PLANNING COMMISSION WORK SESSION MEETING

Tuesday, August 27, 2024 at 7:00 PM

Planning Commission Work Session
SUP 24-01: 71 S. Fifth Street
Car Dealership
August 27, 2024

TO: Casey Squyres, Historic Preservation Planner
FROM: Amber Heflin, CZA, Zoning Official
DATE: July 17, 2024
SUBJECT: Automotive Dealership, 71 S Fifth Street (6984-42-4640-000)
SUP 2024-01
Submission 06/14/2024; 2nd Review

PLAN DATE: JUNE 3, 2024
DESIGN BY: AS
CHECKED BY: JLK
ARCHITECT: N/A
JURISDICTIONAL PLAN NO.
RDA PLAN #: 21171-002
SHEET NUMBER: C.05

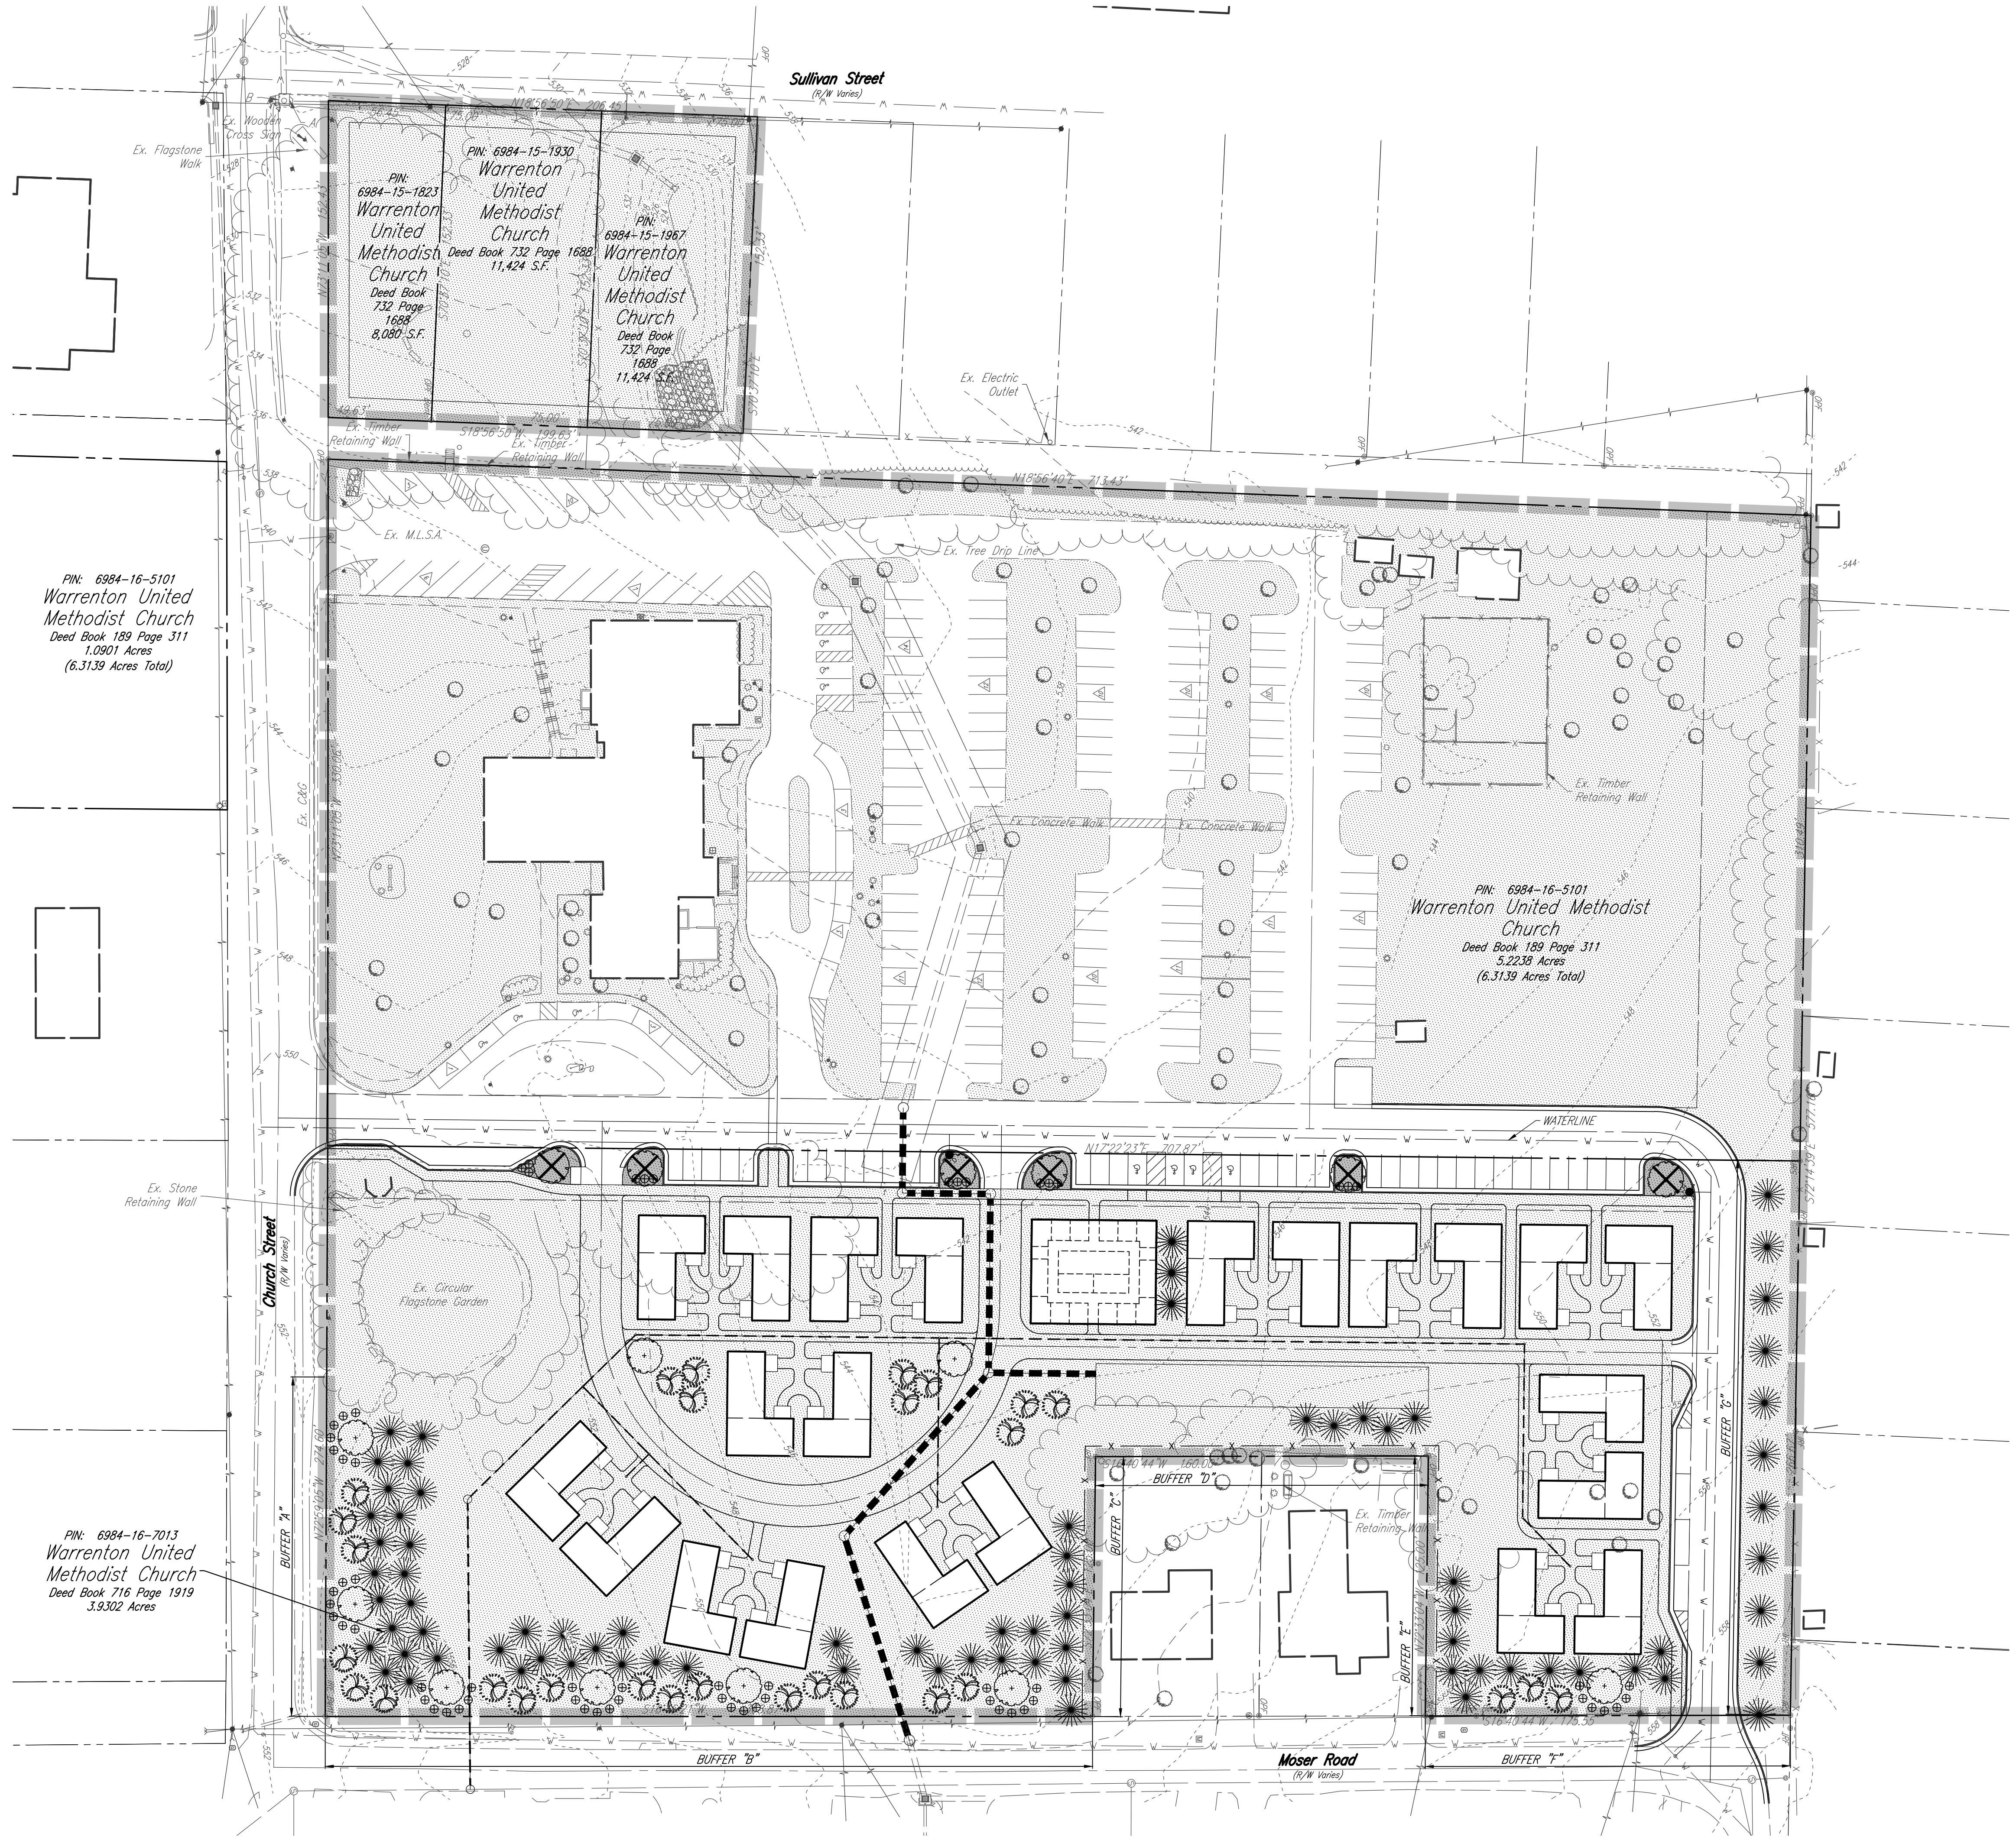
The proposal exceeds the maximum allowable 50% multi-family units.	Acknowledged.
The required open space is not delineated on the plan.	Please see the revised GDP (Sheets C.05 and C.06) where the open space delineation has been added.
The applicants have indicated that the proposed recreational facility may or may not be constructed in phase II dependent on funding; however, applicable recreational facilities must be constructed prior to construction of the next phase.	Please see the revised proffers, which includes more information regarding phasing.

The project area abuts two existing single-family homes off of Moser Road, PIN 6984-16-8079 (Thompson) and PIN 6984-16-8042 (McLaughlin), but does not address how any impacts to these two property owners will be addressed. As a recommendation, the applicant should consider enhanced screening and buffering between the two uses.	Please see the revised GDP (Sheets C.05 and C.06) where a fence and buffer has been added to screen these homes from the project area. These homes will be adjacent to the residential portion of the proposal.
The project area abuts four single family homes to the north, PIN 6984-16-7459 (Hunt), PIN 6984-16-8433 (Southard), PIN 6984-16-9430 (Fransella), and PIN 6984-26-0337 (Church), but does not address how any impacts to these property owners will be addressed. As a recommendation, the applicant should consider enhanced screening and buffering between the access road and the property boundary.	Please see the revised GDP (Sheets C.05 and C.06) where a buffer per the Zoning Ordinance has been added.

SHEET NUMBER: C.07

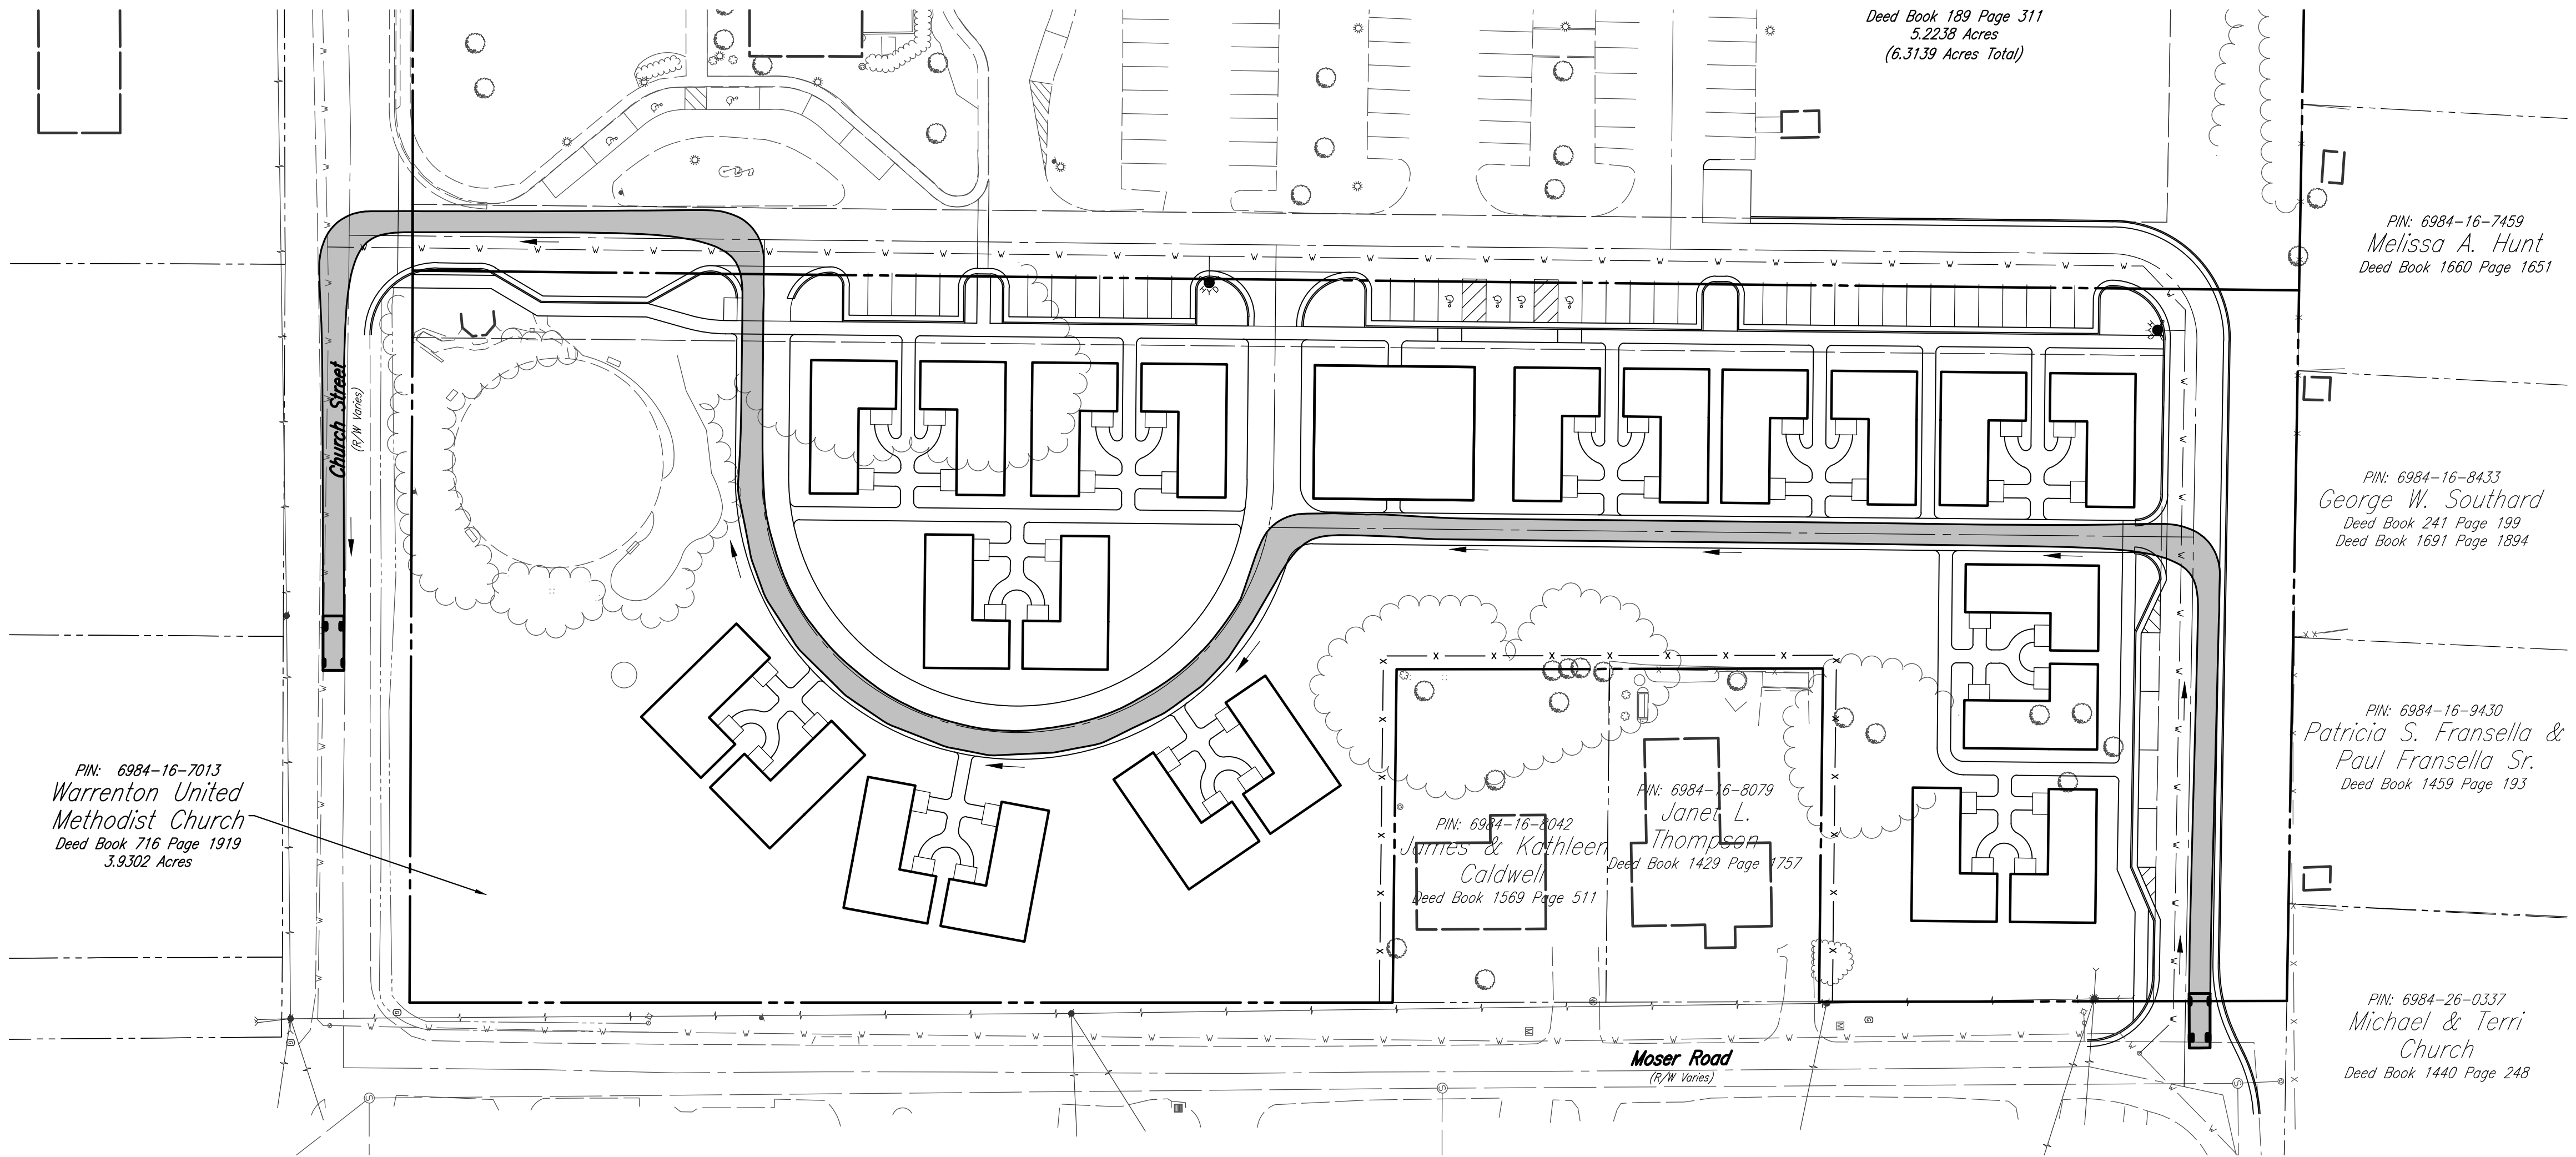
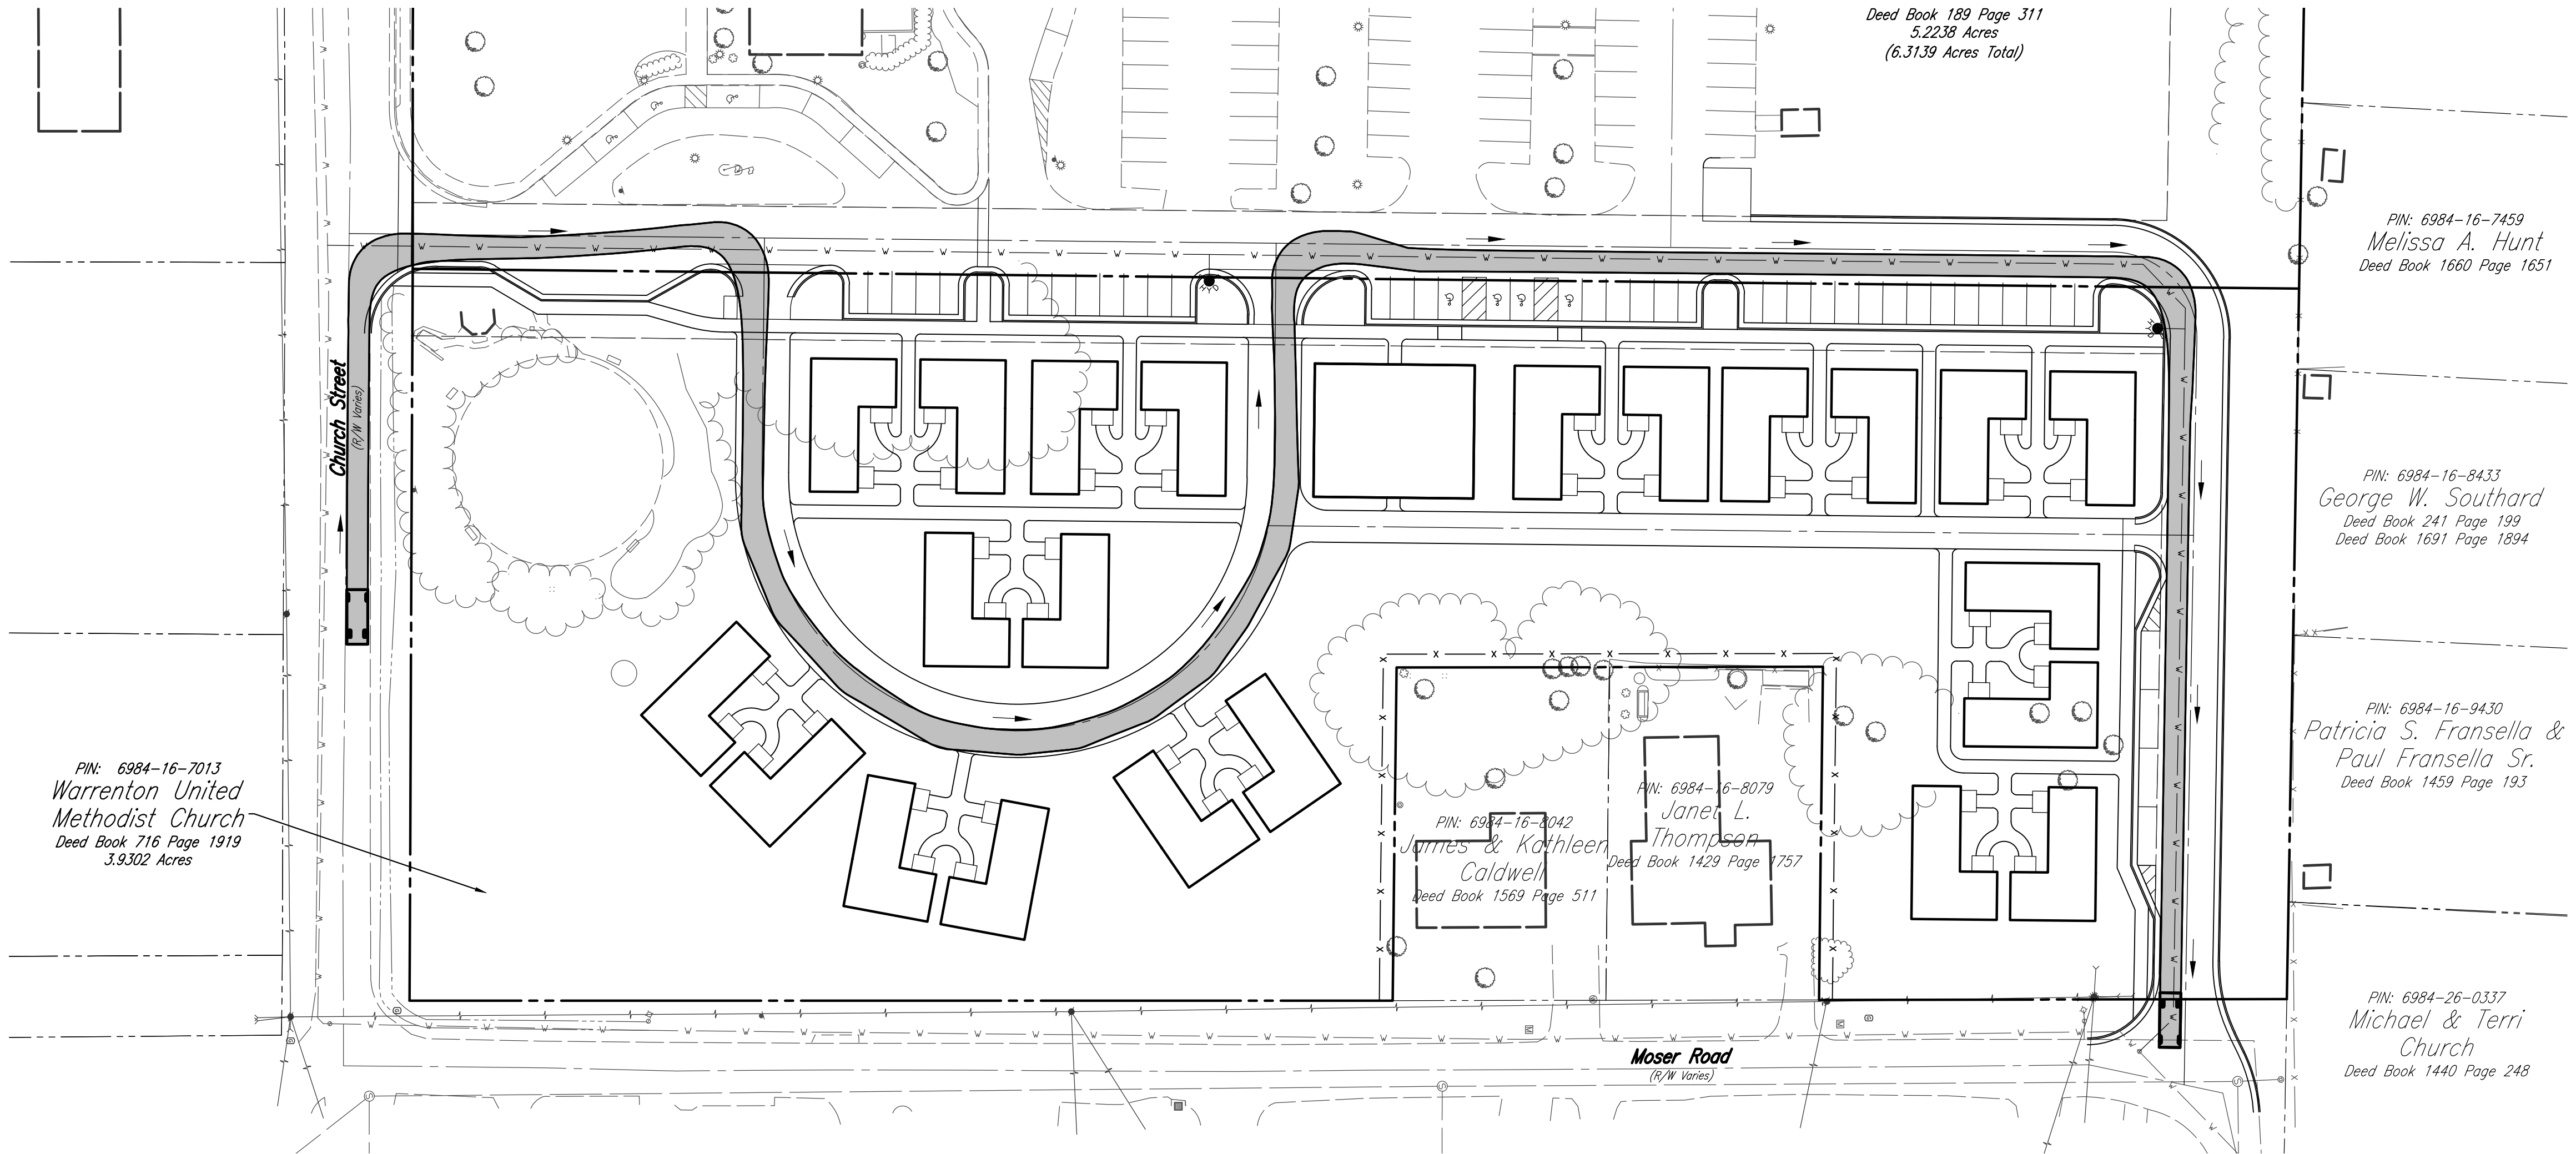
<p>The internal accessways are narrow and appear to have tight turn radii; adequate access by EMS vehicles must be provided to all areas within the project.</p> <ol style="list-style-type: none"> Provide a turn radius/travel path diagram to show that large EMS vehicles can maneuver throughout the site. The existing public roadways appear to be narrow; show that EMS vehicles can access the site from Church Street and Moser Road, to include the Church St./Moser Rd. intersection and the Moser Rd./Frazier Rd. intersection. 	Please see the revised GDP (Sheets C.09 and C.10), which includes a sheet depicting vehicle turning analyses for EMS vehicles.
As a recommendation, the applicant should indicate how fire suppression/protection will be addressed, such as building construction	The Applicant will address this in connection with site plan review.

NOTE: AMBULANCE VEHICLE TRACKING PATH CREATED USING
A HORTON 453 TYPE III FORD E-SERIES AMBULANCE VEHICLE
(DIMENSIONS=20.4'x7.8')
